# Consultants Final Lot Grading Certification Letter

**Re:      Municipal Address:**      1344 Harrington Street  
**Lot or Block No.:**      Lot 63  
**Registered Plan No.:**      2021-0380  
**Certification of building and final lot grading**  
**Bellaire Properties Inc.**

1344 HARRINGTON STREET  
LOT 63, PLAN 51M-1088  
PHASE 2, STAGE  
BELLAIRE PROPERTIES INC.  
PARCEL P1 - LEFROY  
TOWN OF INNISFIL

**A-1**

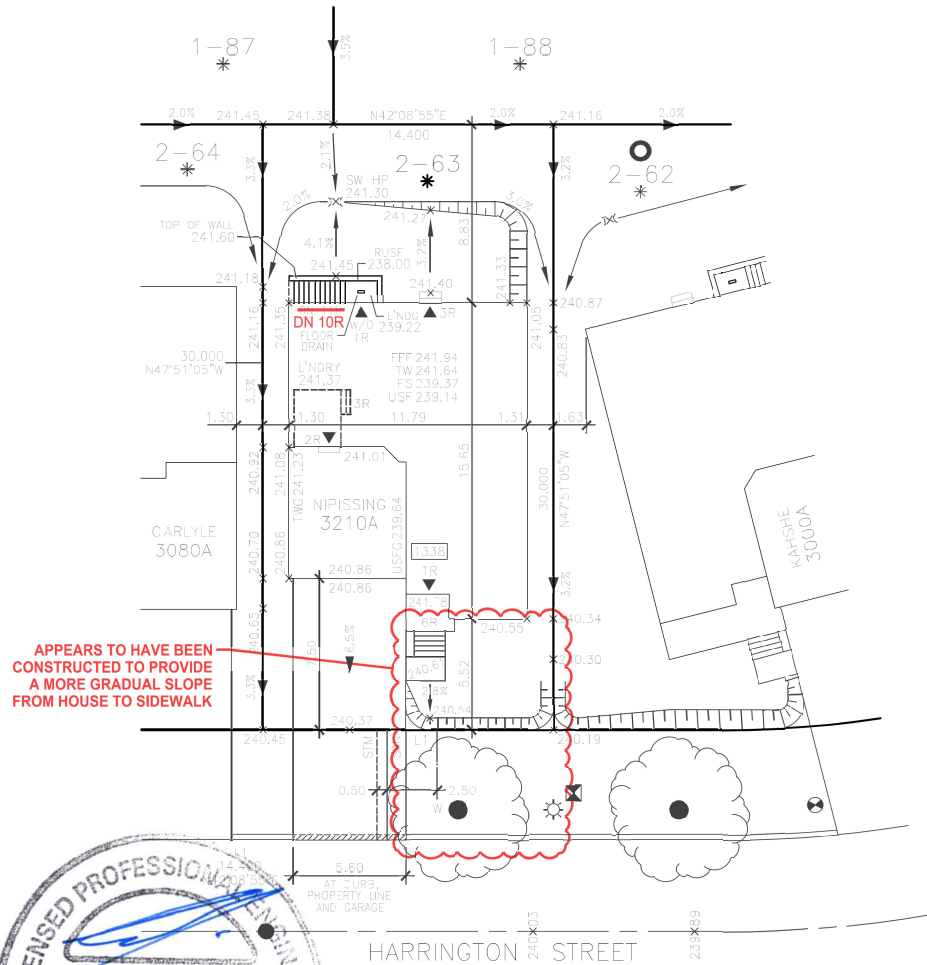
1. The lot grading and building elevations on the above referenced lot are:
  - ☐ In conformity with the approved grading and site plans
  - ☒ Not in conformity with the approved plan, but have been constructed in accordance to sound engineering principles and vary from the approved plan as shown on the attached "as-built" plan, signed and stamped by the undersigned, subject to approval by the Town of Innisfil.
2. The water service "curb-stop" is located in the grassed portion of the front yard, is accessible, and is flush with finished grade.

NO.	REVISIONS	DATE	INITIAL
2	ADDED REDLINE COMMENTS	JN 20 23	B.J.J.
1	REVISED PER ISI GROUP REVIEW	AP 27 21	TP
-	ISSUED	AP 23 21	TP
